## REVISED RESPONSE TO REQUEST FOR ADDITIONAL INFORMATION

### APR1400 Design Certification

Docket No. 52-046

RAI No.: 222-8203  
SRP Section: 11.05 – Process and Effluent Radiological Monitoring Instrumentation and Sampling Systems  
Application Section: 11.5  
Date of RAI Issued: 09/23/2015

Figure 11.5-3C Monitor Assembly for Main Steam Line Effluent + N-16 Detectors

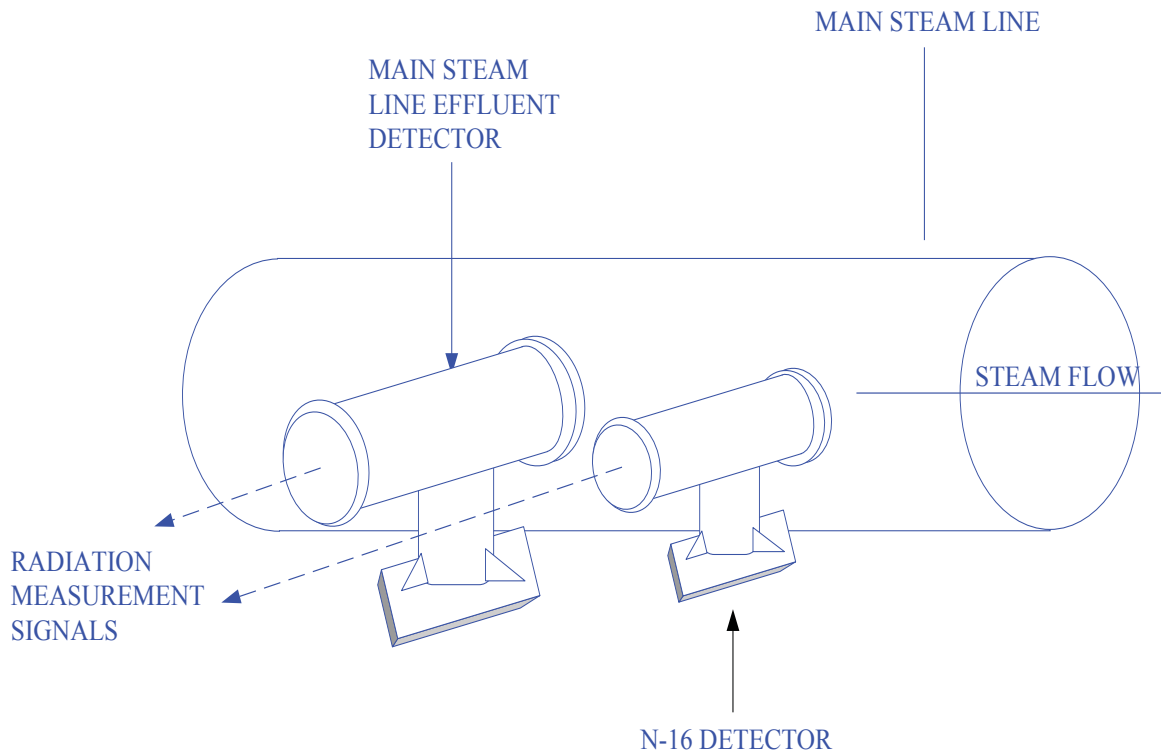
Because the reactor coolant system (RCS) is a safety-related system, steam generator (SG) tube integrity is a safety-related issue. 10 CFR 52.47(b)(1) requires that a DC application contain the proposed ITAAC that are necessary and sufficient to provide reasonable assurance that, if the inspections, tests, and analyses are performed and the acceptance criteria met, that a plant that incorporates the design certification is built and will operate in accordance with the design certification and the provisions of the Atomic Energy Act, and NRC regulations. The applicant has not provided adequate Tier 1 ITAAC information to verify the compliance with the design criteria.

The ITAAC should address the sensitivity, response time, and alarm limit for the SG Tube leakage detection instrumentation. The staff requests the applicant to provide ITAAC for this system in the DCD Tier 1.

Please address this item and provide a markup for the proposed DCD changes.

The APR1400 design provides for the monitoring of radioactive releases from the MSSV and MSADV during SGTR using the Main Steam Line Effluent Detectors, which is an additional function of RE-217 ~ RE-220.

This is required by RG 1.97 Rev.3 and the RMS purchase specifications require the supplier comply with this requirement. Please refer to DCD Tier 2, Subsection 11.5.2.2.5.m and Figure 11.5-3C.

One monitor on each of the four main steam lines is provided in the main steam line support structure. The monitors are placed as close as possible to the pipe as shown in Figure 11.5-3C, upstream of the main steam atmospheric dump valves and main steam safety valves.

1. The main steam line (MSL) effluent monitor detects the radioactive effluent discharge through MSSV's, MSADV and AUX feedwater pump exhaust. This detector performs the function required by NRC RG 1.97.
2. The N-16 detector senses the SG tube leak.
3. Depending on the supplier, the two detectors (MSL and N-16) is assembled as one unit or the two are mounted as two separate but adjacent unit as shown above.

Added
